RE: **60 BAY AVE HIGHLANDS, LLC**
Response Letter (HLPB2024-02)
Block 42, Lot 1;
60 Bay Avenue
Borough of Highlands, Monmouth County, New Jersey

We are submitting this letter on behalf of the Owner/Applicant in response to Roberts Engineering Group LLC's Review Letter dated May 21, 2025. Each comment and response are numbered in accordance with the aforementioned review memo. *Italicized text is taken from the review memo for your ease of reference;* non-italicized text represents our responses.

Review Letter, dated May 21, 2025

PRELIMINARY & FINAL MAJOR SITE PLAN FOR PROPOSED MULTI-FAMILY RESIDENCE

APPROVED BY:
☐ FOR CONSTRUCTION

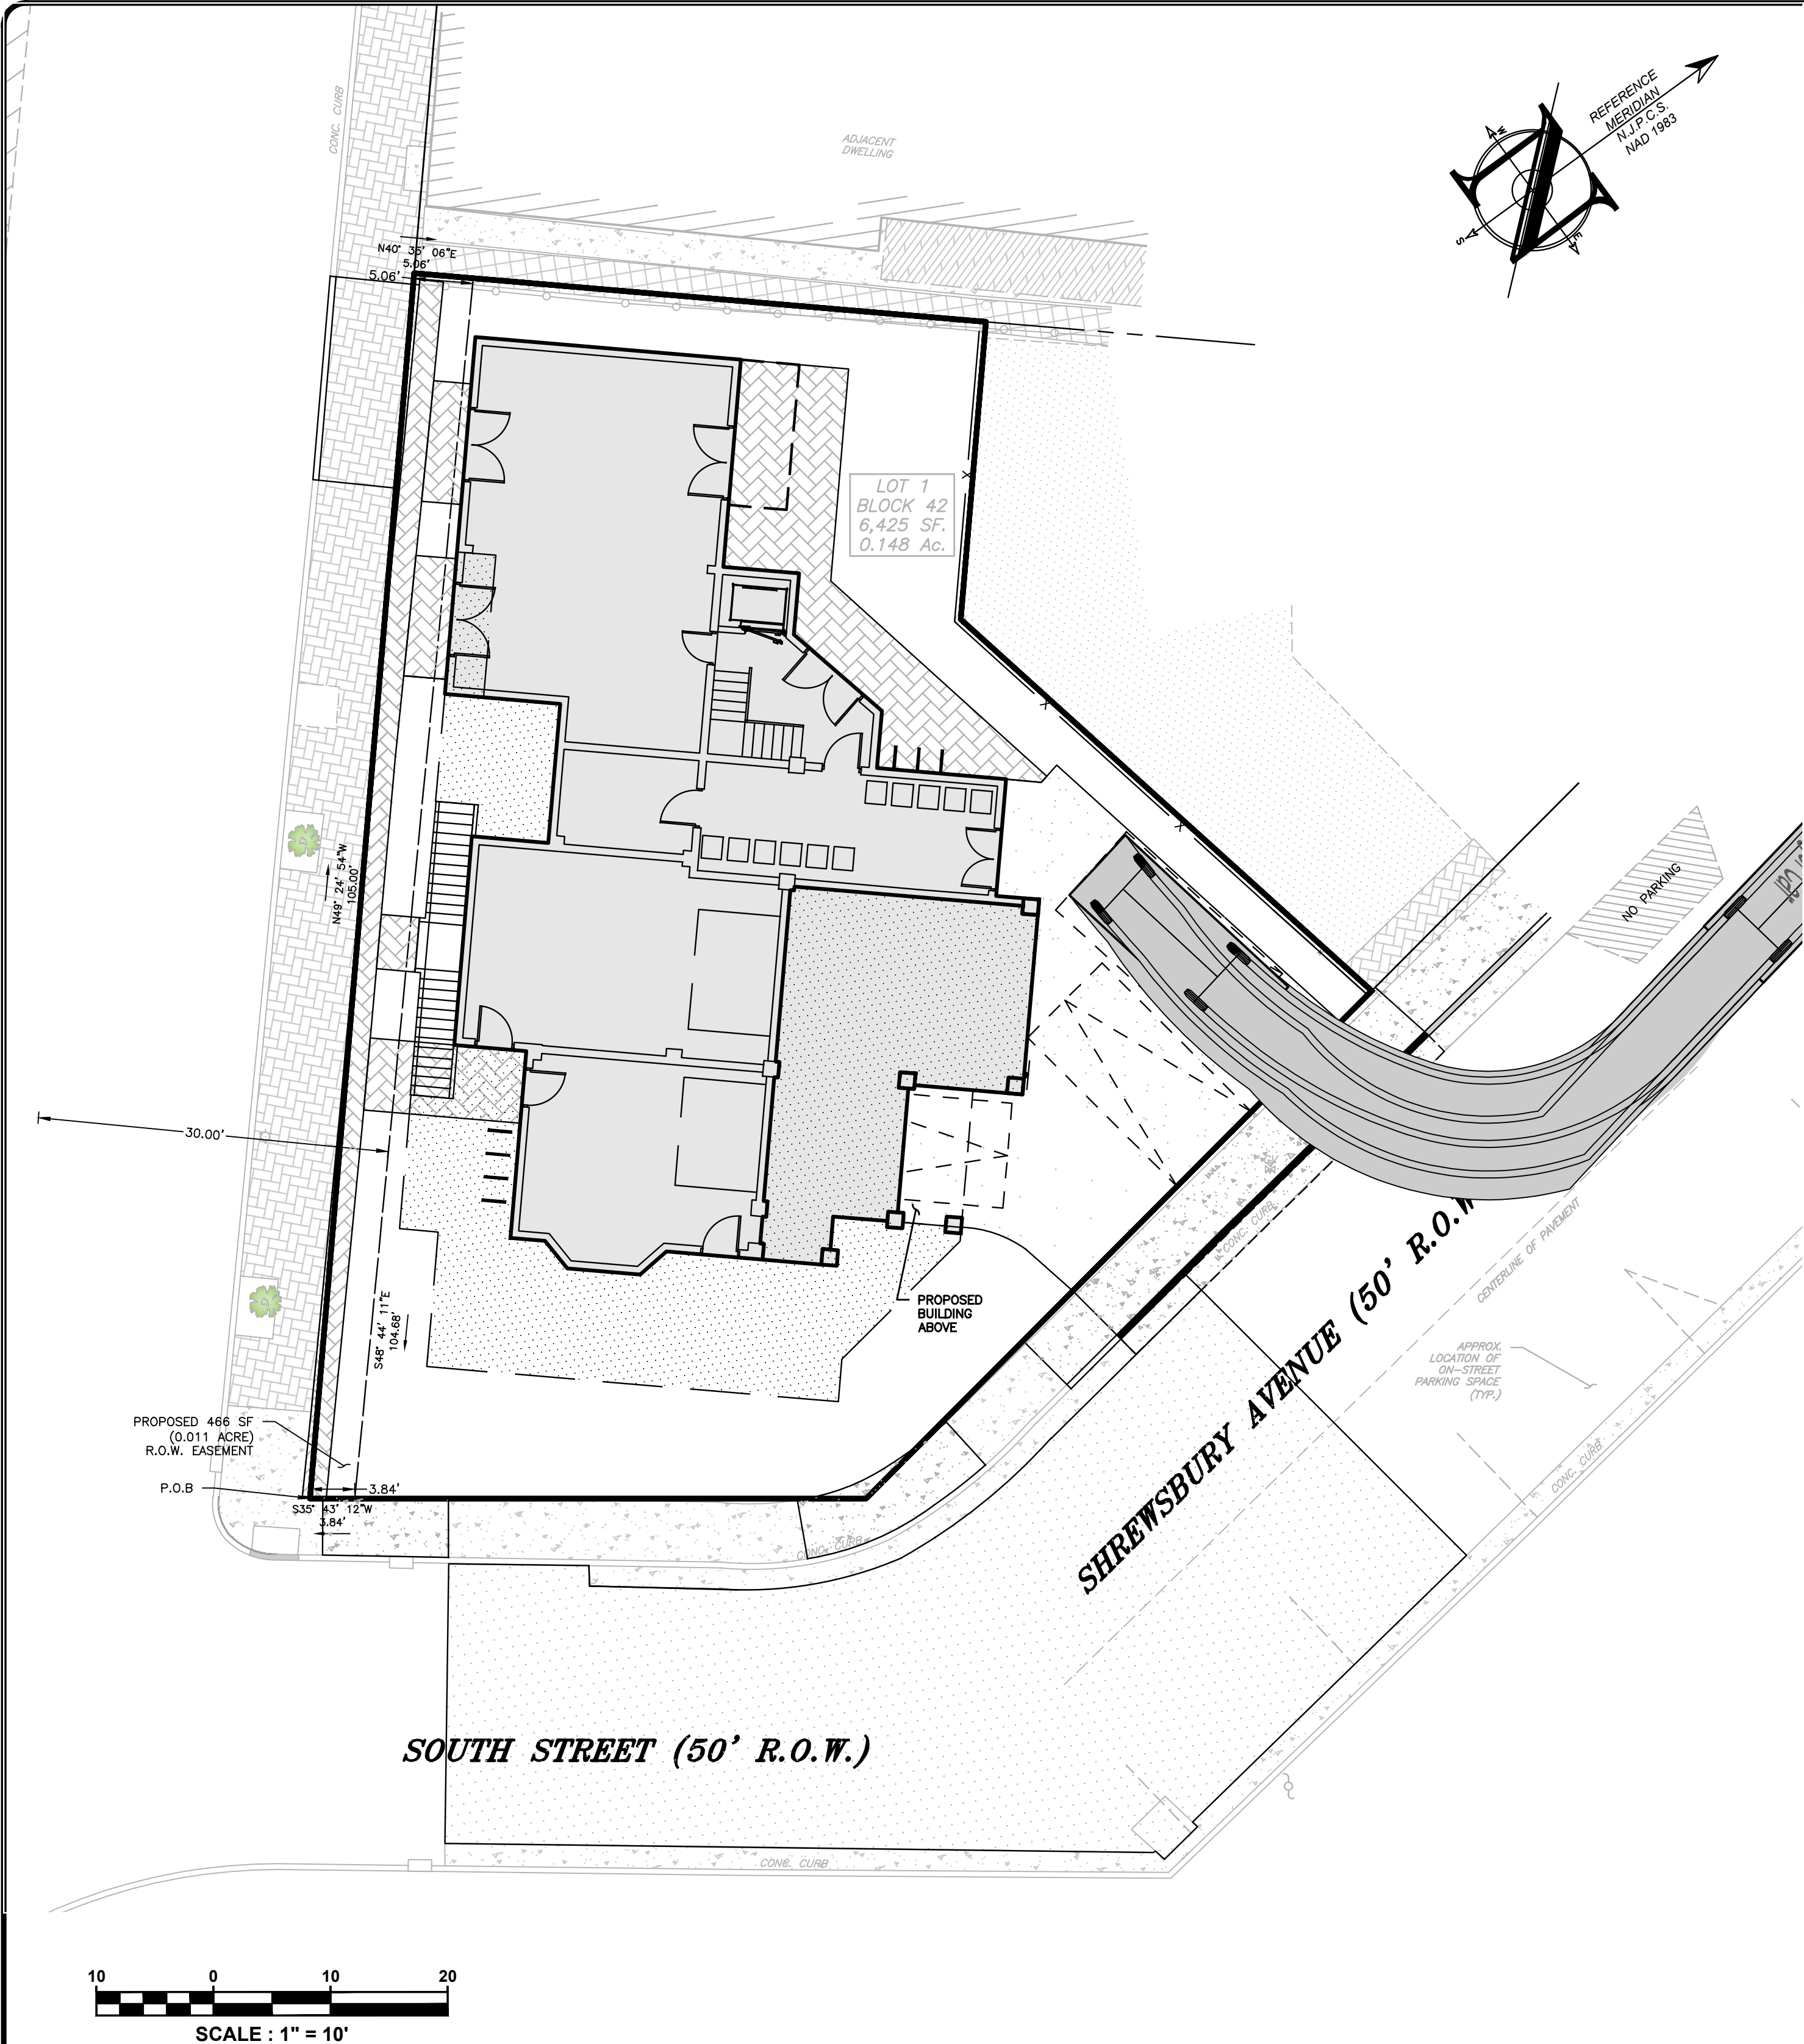
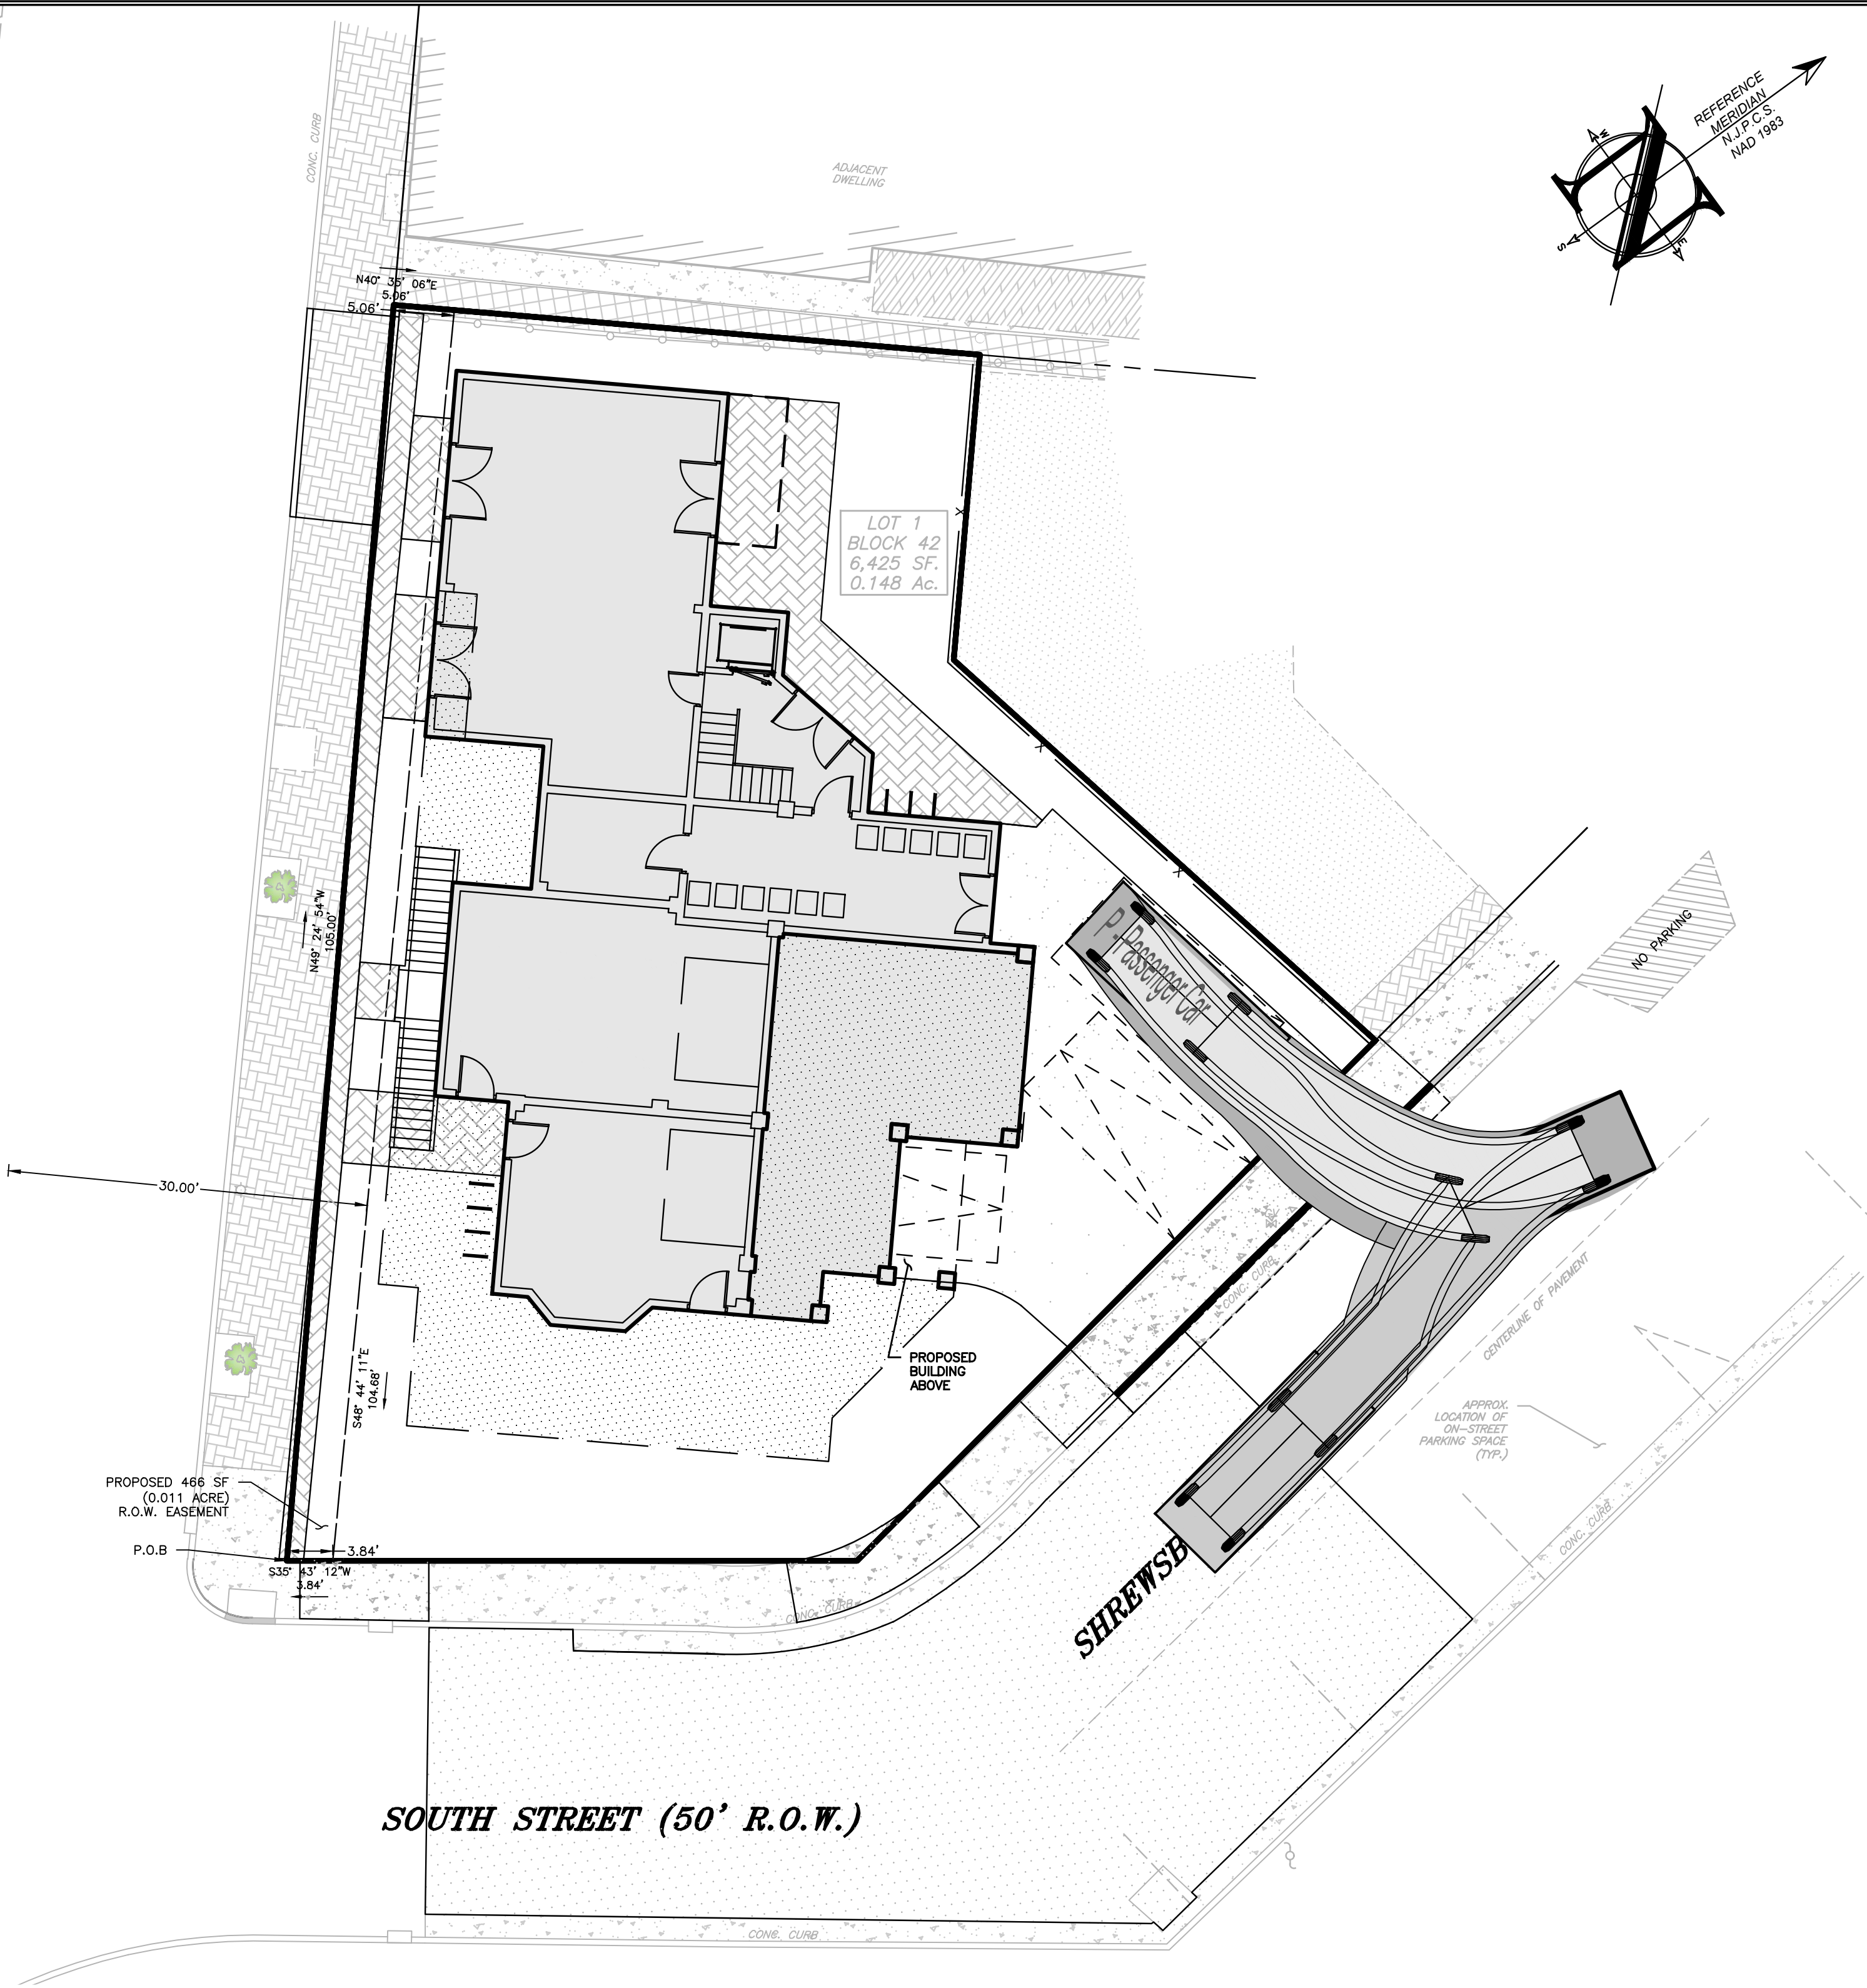
10. *The Applicant has provided six (6) circulation plans indicating the existing parking spaces along Shrewsbury Avenue. The circulation plans demonstrate vehicles maneuvering Shrewsbury Avenue by accessing the driveways and garages. These maneuvers are of great concern and appear so difficult as to be questionable.*

We question the size and location of the driveways. The turning templates provided for maneuvers in and out of the garages require turns, starts and stops. Some of the turning templates indicate that vehicles must drive into opposing traffic to be able to enter the driveways and garages.

In addition, garages on Shrewsbury Avenue appear to show that cars cannot enter and exit without sideswiping the door opening. When a car is parked in the space near the rear property line, the vehicle entering and exiting the garage on to Shrewsbury Avenue seems to sideswipe the parked car. Please explain.

The Applicant is to provide specific testimony and presentation to clearly show how all driveways will be accessed from Shrewsbury Avenue, and how all garages will be entered, without driving into opposing traffic. The applicant must provide details of how these driveways will allow for proper and safe operation for entering and exiting.

The turning movement plans were revised to show pulling in and pulling out of each of the parking areas, while considering the location of parked vehicles. The centerline

of Shrewsbury Avenue was added to the plan and no lane incursions into opposing traffic are proposed.
